CHESTERFIELD PLACE SUBDIVISION

RESUBDIVISION OF LOT 26

APPLICATION NUMBER 2 DATE August 6, 2009
APPLICANT Chesterfield Place Subdivision, Resubdivision of Lot 26
REQUEST Subdivision

DETAIL SITE PLAN

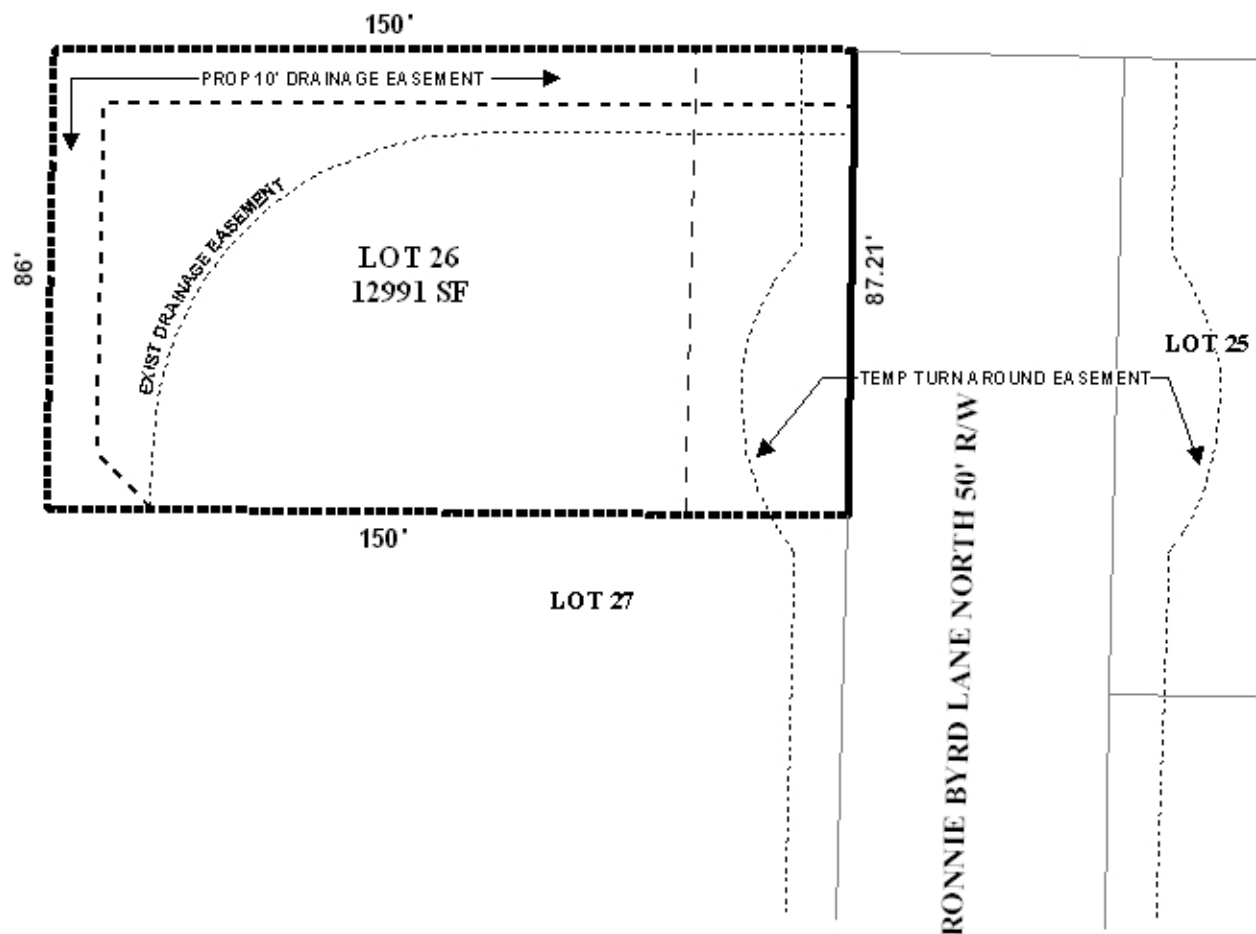
The purpose of this application is to re-subdivide an existing legal lot of record to revise a drainage easement along the rear and side property lines.

The lot has approximately 87' of frontage along Ronnie Byrd Lane North. As a means of access management, a note should be placed on the final plat stating that the subdivision is limited to one curb cut to Ronnie Byrd Lane North, with the size, location, and design to be approved by County Engineering and in conformance with AASHTO standards.

Section V.B.14 of the Subdivision Regulations has also been amended since the original approval of Chesterfield Place in 2006. In accordance with the 2003 International Fire Code, all streets longer than 150' are required to have a cul de sac of appropriate size for fire trucks to turn around (minimum 120' right-of-way diameter). As illustrated, the lot fronts a temporary turn-around with a right-of-way width of 90'. However, as already mentioned, the applicant is not proposing any changes in the dimensions in the lot; only the revision of a drainage easement. Therefore, a waiver here may be appropriate.

It should also be noted the plat illustrates a 30' minimum building setback line from Ronnie Byrd Lane North, which exceeds the requirement of Section V.D.9 of the Subdivision Regulations.

- 1) placement of a note on the final plat stating that the subdivision is limited to one curb cut to Ronnie Byrd Lane North, with the size, location, and design to be approved by County Engineering and in conformance with AASHTO standards;

- 4) provision of a minimum detention capacity volume of a 50 year post development storm, with a maximum release rate equivalent to the 10 year storm pre-development rate, and the placement of a note on the final plat stating that the development has been designed to comply with all other storm water detention and drainage facility requirements of the City of Mobile storm water and flood control ordinances, and requiring submission of certification from a licensed engineer certifying that the design complies with the storm water detention and drainage facility requirements of the City of Mobile storm water and flood control ordinances, as well as the detention and release rate requirements of Mobile County for projects located within the Converse watershed, prior to the obtaining of permits. Certification is to be submitted to the Planning Section of Urban Development and County Engineering.
